8 SUB-000624-2018

CAZALAS ESTATES SUBDIVISION

DETAIL SITE PLAN

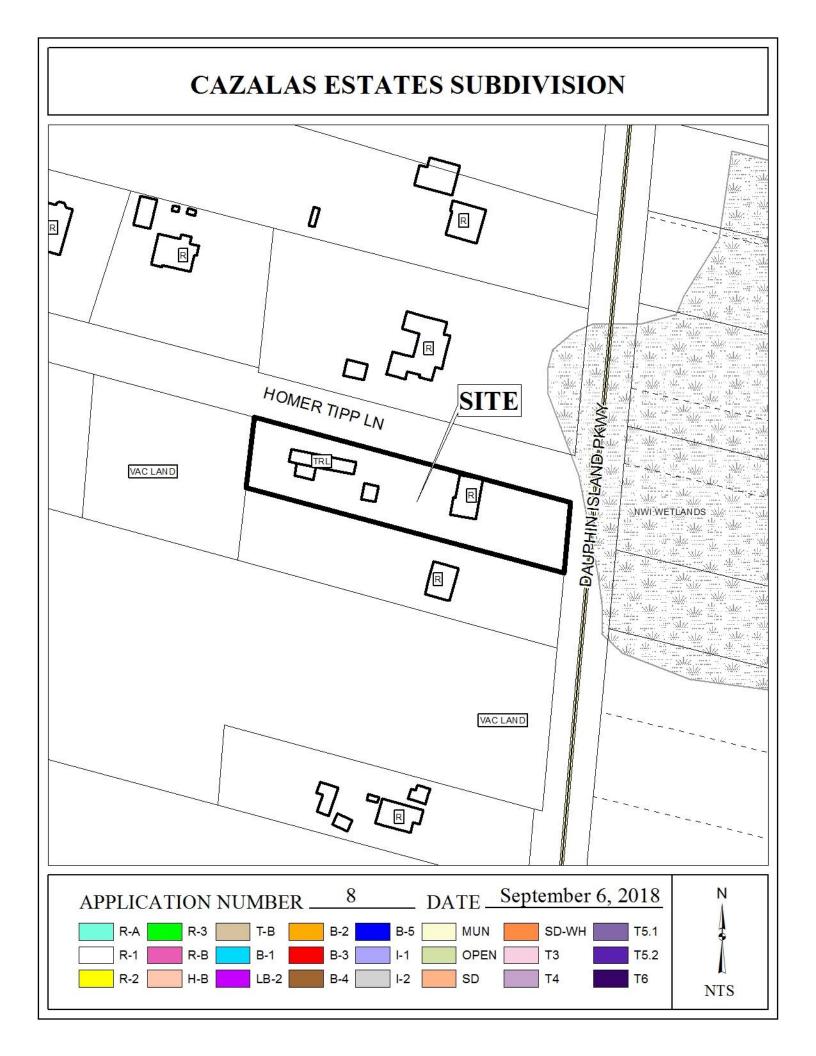
The proposed lots each have frontage along Homer Tipp Lane, an unpaved minor street without curb and gutter requiring a 60' right-of-way. Proposed Lot 2 also has frontage along Dauphin Island Parkway which, at this location, is a minor street without curb and gutter, also requiring a 60' right-of-way. The plat illustrates a 50' right-of-way along Homer Tipp Lane, and a varying right-of-way along Dauphin Island Parkway. As such, revision of the plat to illustrate dedication sufficient to provide 30' from the centerlines of both Homer Tipp Lane and Dauphin Island Parkway should be required, if approved. Also, because it is substandard in terms of roadway width and surfacing, a note should be required on the Final Plat stating there shall be no future subdivision of either lot until Homer Tipp Lane is improved in width and paved in asphalt to Mobile County Engineering standards.

Revision of the plat to illustrate dedication of a 25' corner radius at the intersection of Homer Tipp Land and Dauphin Island Parkway, in compliance with Section V.D.6. of the Subdivision Regulations, should be required, if approved.

Both lots meet the minimum size requirements for lots served by public water and individual septic systems and are appropriately labeled in square feet and acres on the preliminary plat; however, the dedication of right-of-way may result in Lot 2 being less than 15,000 square-feet, which is the minimum size required for a lot with public water and an individual septic system. As such, the applicant must ensure that each lot will be at least 15,000 square-feet in size, after dedication. Also, the sizes of each lot should be retained in square-feet and acres on the Final

If approved, revision of the plat to illustrate the 25' minimum building setback along Homer Tipp Lane and Dauphin Island Parkway should be required, per Section V.D.9. of the Subdivision Regulations.

As a means of access management, a note should be placed on the Final Plat stating Lot 1 is limited to its existing curb cut(s) to Homer Tipp Lane, and Lot 2 is limited to one (1) curb cut each to Homer Tipp Lane and Dauphin Island Parkway, with any changes in their sizes, locations, or designs to be approved by Mobile County Engineering and conform to AASHTO standards.

- 1) revision of the plat to illustrate dedication sufficient to provide 30' from the centerlines of both Homer Tipp Lane and Dauphin Island Parkway;
- 2) revision of the interior lot line to ensure each lot will be at least 15,000 square-feet in size after right-of-way dedication;

- 3) retention of the lot sizes in square feet and acres on the Final Plat, or provision of a table providing the same information;
- 4) revision of the plat to illustrate dedication of a 25' corner radius at the intersection of Homer Tipp Land and Dauphin Island Parkway, in compliance with Section V.D.6.;

- 5) revision of the plat to illustrate the 25' minimum setback line along all street frontages, in compliance with Section V.D.9.;
- 6) placement of a note on the Final Plat stating Lot 1 is limited to its existing curb cut(s) to Homer Tipp Lane, and Lot 2 is limited to one (1) curb cut each to Homer Tipp Lane and Dauphin Island Parkway, with any changes in their sizes, locations, or designs to be approved by Mobile County Engineering and conform to AASHTO standards;
